Access Compliance Report

Public Rights-of-Way

(Curb Ramps)

Intersection ID: 17467	Main Street: CROYDON_RD	Cross Street: STERLING_RD	Location: SW
ADA ID: FE546A585AA8	Ramp Type: PerpDiag	Initial Pass/Fail: Fail	Overall Compliance: No
Severity Score: 12.5			
Codes/Mitigation Info/Possible Solution		Field Measurements/Component Compliance

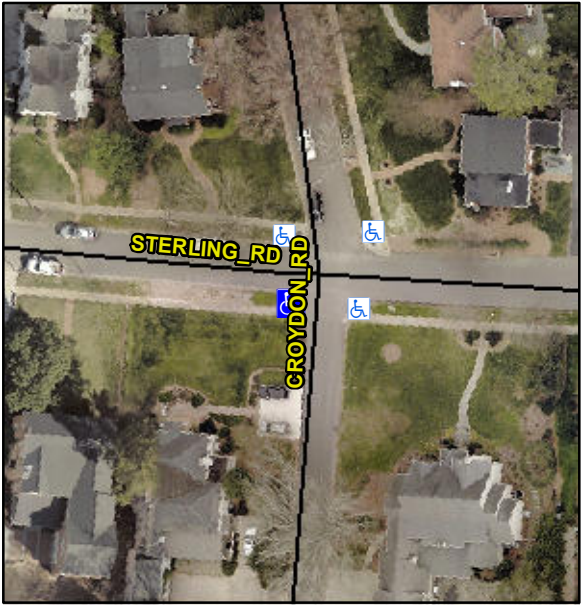
Possible Solutions:		Compliance	Description	Data	Compliance	Description	Data
	Remove & Replace Curb Ramp With Two New Directional Ramps or Equivalent.		N/A	Ramp Length (in)	85.0	Yes	Ramp Slope (%)	6.5
<p>Surveyor Notes:</p> <p>N/A</p> <p>PROW/ADA:</p> <p>R304.5.3</p>			Yes	Ramp Width (in)	50.0	No	Ramp XSlope (%)	5.6
			N/A	Flare Type LT	N/A	N/A	Flare Type RT	N/A
			N/A	Flare Slope LT (%)	N/A	N/A	Flare Slope RT (%)	N/A
			N/A	Flare Traversable LT?	N/A	N/A	Flare Traversable RT?	N/A
			N/A	Landing Length (in)	N/A	N/A	DWS Provided?	N/A
			N/A	Landing Width (in)	N/A	N/A	DWS Contrast?	N/A
			N/A	Landing Slope (%)	N/A	N/A	DWS Length (in)	N/A
			N/A	Landing X Slope (%)	N/A	N/A	DWS Full Width?	N/A
			N/A	Landing Curb? (Y/N)	N/A	N/A	DWS Offset (in)	N/A
			N/A	Shared Landing?	N/A			
			N/A	Gutter Ponding?	N/A	N/A	Gutter Slope (%)	N/A
			N/A	Gutter Lip Ht (in)	N/A	N/A	Gutter X Slope (%)	N/A
			N/A	Painted X Walk1?	No	N/A	Painted X Walk2?	No
